#15-NA-016: Creak or Snap Noise Above Windshield from Removable Roof Lift Off Panel While Driving - (Sep 30, 2015)

Subject: Creak or Snap Noise Above Windshield from Removable Roof Lift Off Panel While Driving

Brand:	Model:	Model Year:		VIN:		Engine:	Transmission:
		from	to	from	to		
Chevrolet	Corvette	2014	2015			All	All

- (1) Example of a bad front locating pin.
- (2) Example of a good front locating pin.

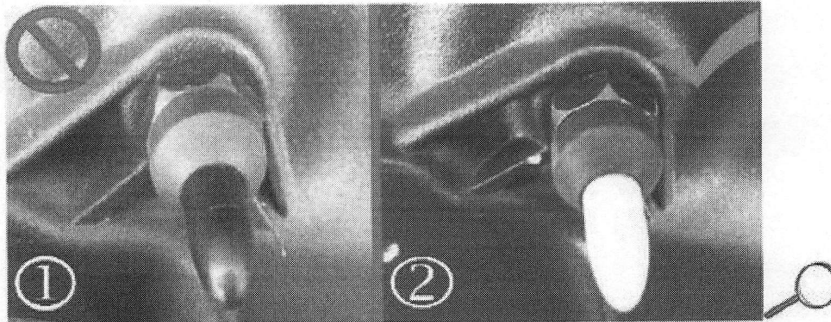
Condition	Some customers may comment on a creak or snap noise from the front of the removable roof lift off panel while driving. The noise is more predominant when ambient temperatures are high.
Cause	This may be caused by a stick-slip condition between the front latches against the strikers and the front locating pins to the locating cup in the strikers.

If you encounter a vehicle with the above concern, replace both the front roof lift off panel strikers and both front locating pins. Refer to Roof Lift Off Panel/Window Front Striker Replacement and Removable Top Locating Pin Replacement in SI.
